Office Action Summary	Application No. 10/532,183	Applicant(s) PIERRET ET AL.	
	Examiner Burton S. Mullins	Art Unit 2834

DETAILED ACTION

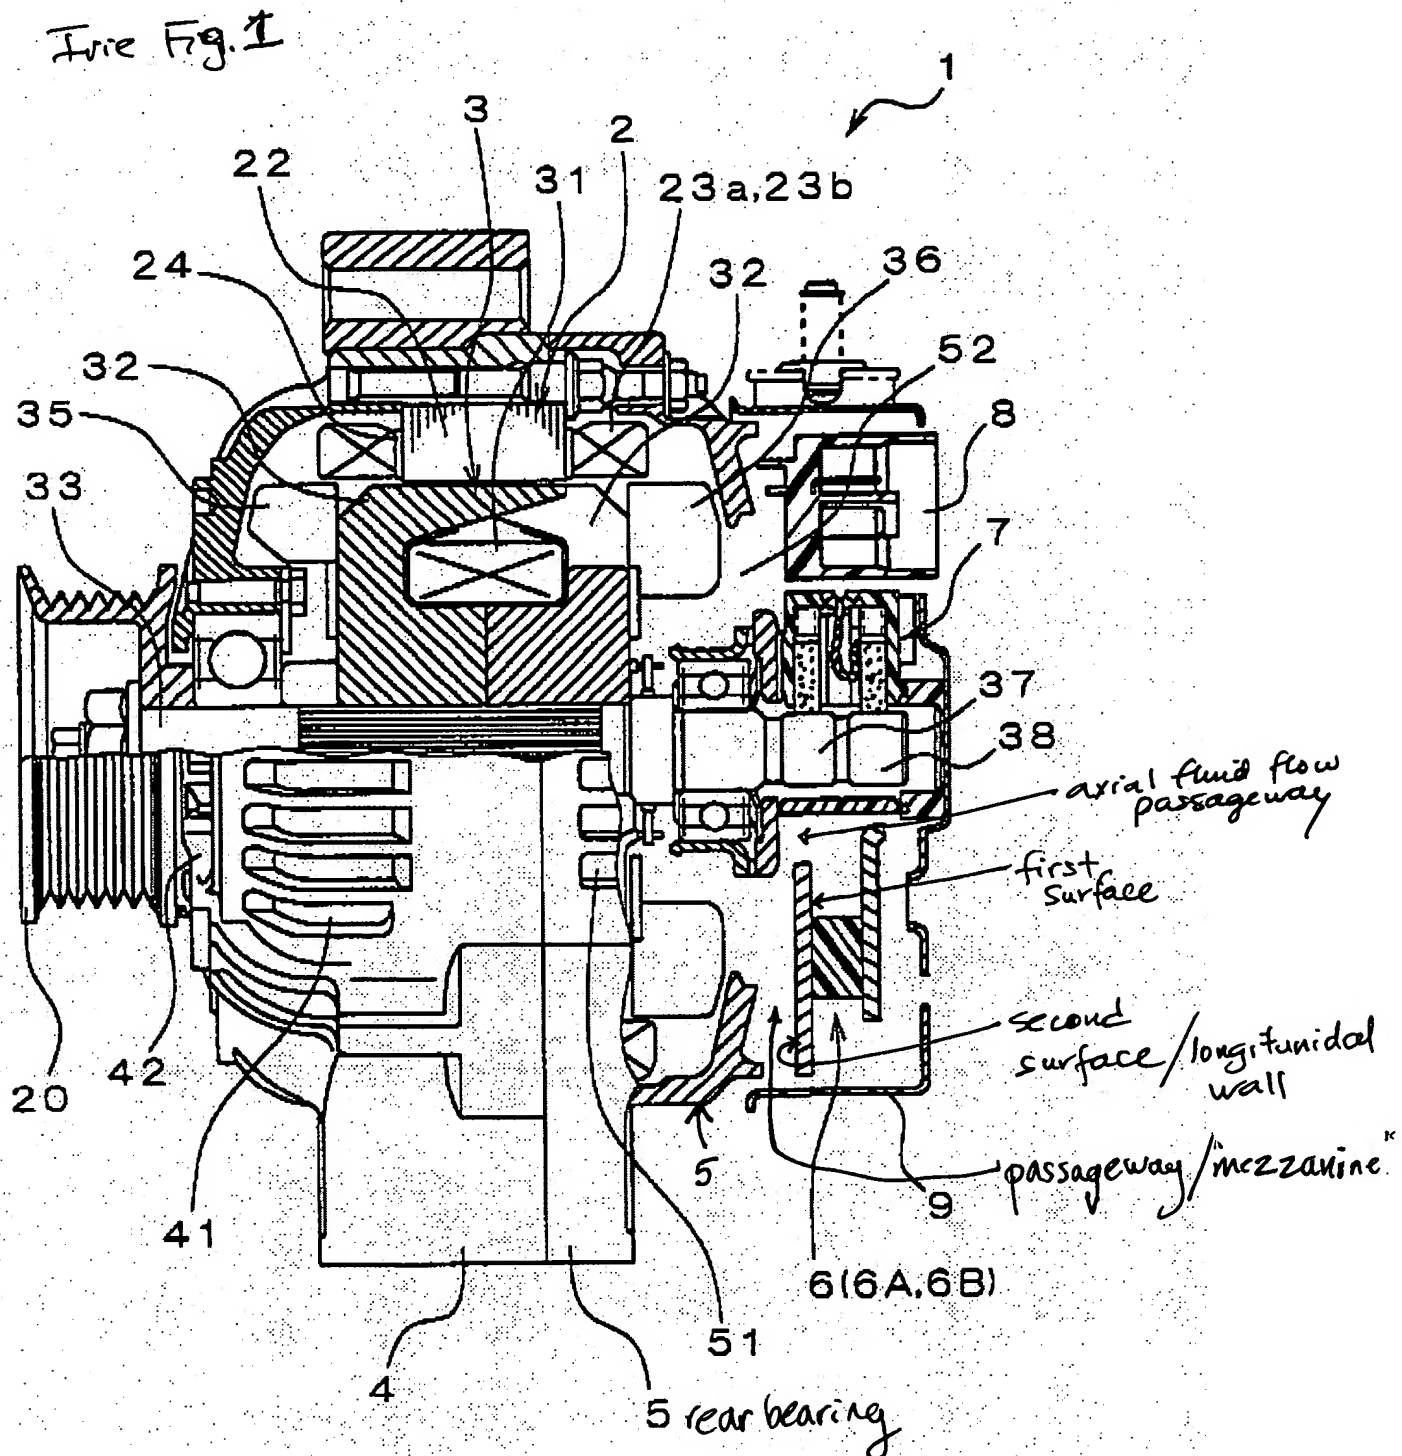
6. Claims 14 and 18 are rejected under 35 U.S.C. 112, second paragraph, as being indefinite for failing to particularly point out and distinctly claim the subject matter which applicant regards as the invention. In claim 14, the term “mezzanine” is vague and indefinite because it is not clear what structural features this term imparts to the claim. For purposes of comparison with the prior art, the term will be interpreted as meaning a space above the rear bearing. In claim 18, the phrase “away from the bearing” is vague and indefinite. It will be interpreted as meaning the fins are separate from the rear bearing.
